## PIC18FXX2 Rev. B3/B4 Silicon/Data Sheet Errata

The PIC18FXX2 Rev. B3/B4 parts you have received conform functionally to the Device Data Sheet (DS39564B), except for the anomalies described below.

**The following silicon errata apply only to PIC18FXX2 devices with these Device/Revision IDs:**

**FIGURE 1: PINOUT DIAGRAM FOR PIC18F442/452, 44-PIN QFN PACKAGE**

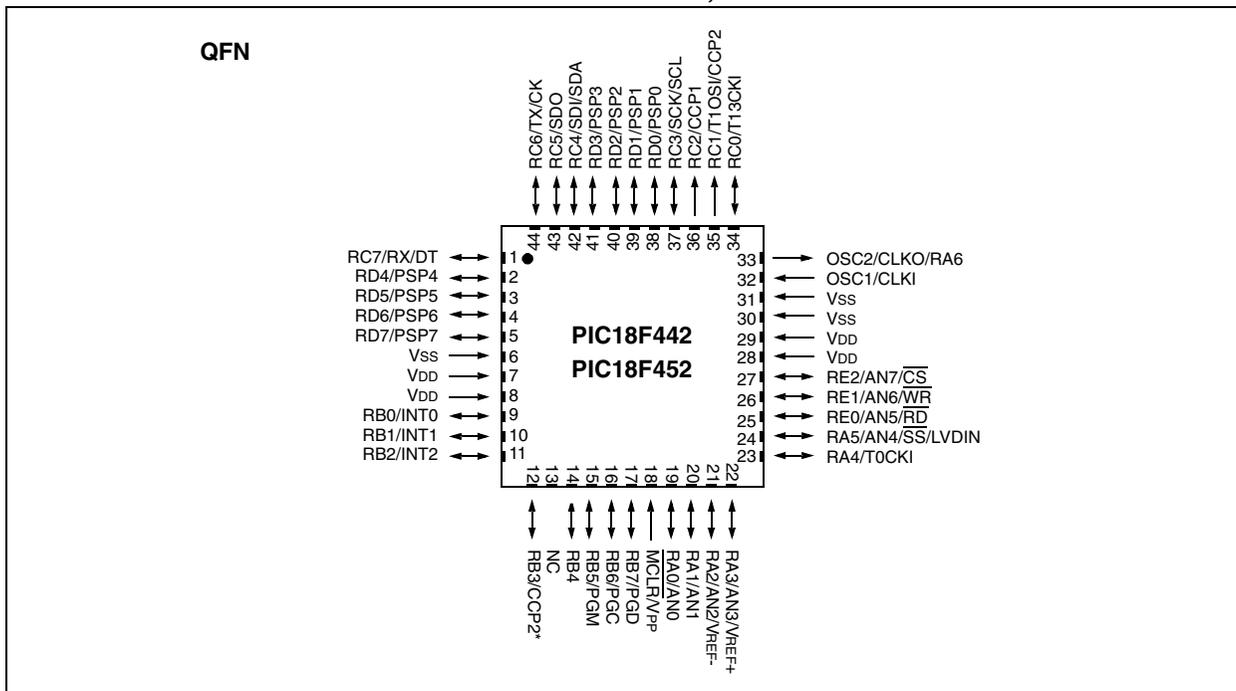
PIC18F442 and PICF452 devices are now offered in 44-pin, near chip-scale micro lead frame packages (commonly known as “QFN”). This packaging type has been added to the product line since the latest revision of the Device Data Sheet.

1. The “Pin Diagrams” on pages 2-3 of the Data Sheet are amended with the addition of the 44-pin QFN pinout, shown in Figure 1.
2. Table 1-3 of **Section 1.0 “Overview”** is replaced with an updated version which adds a column for QFN pin assignments. A row is also added for previously unlisted NC pins. All new information is indicated in **bold**.

**FIGURE 3: 44-PIN QFN PACKAGE**

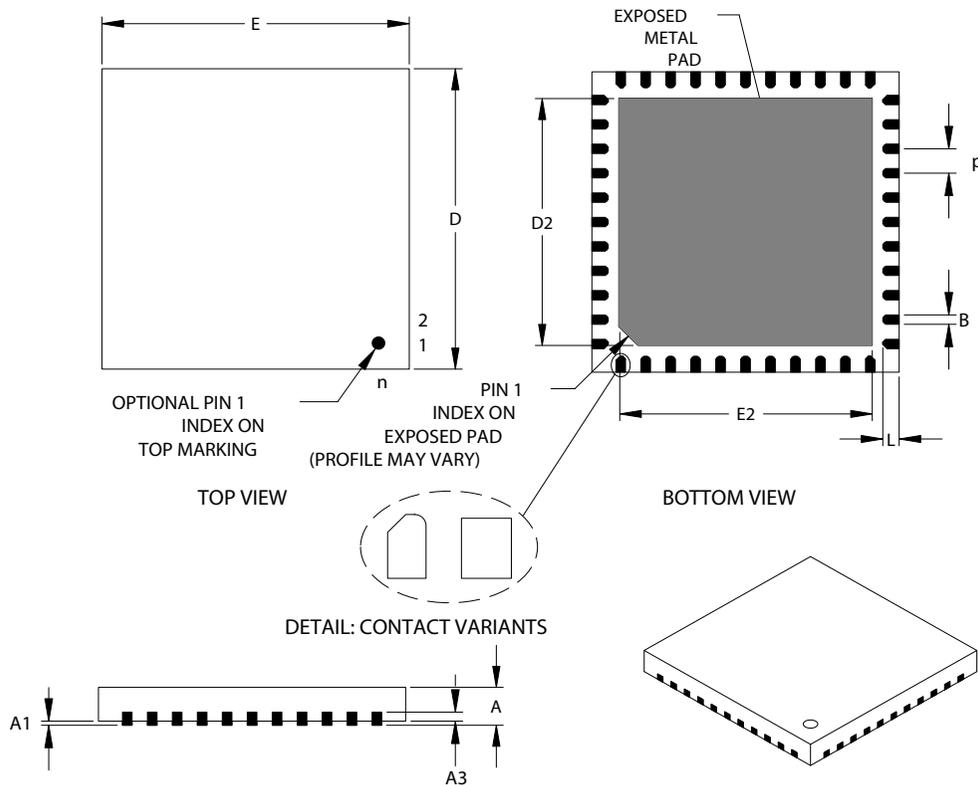
4. **Section 24.2 (Package Details)** is amended to include the mechanical drawing of the 44-pin QFN package following the existing drawings, shown in Figure 3.
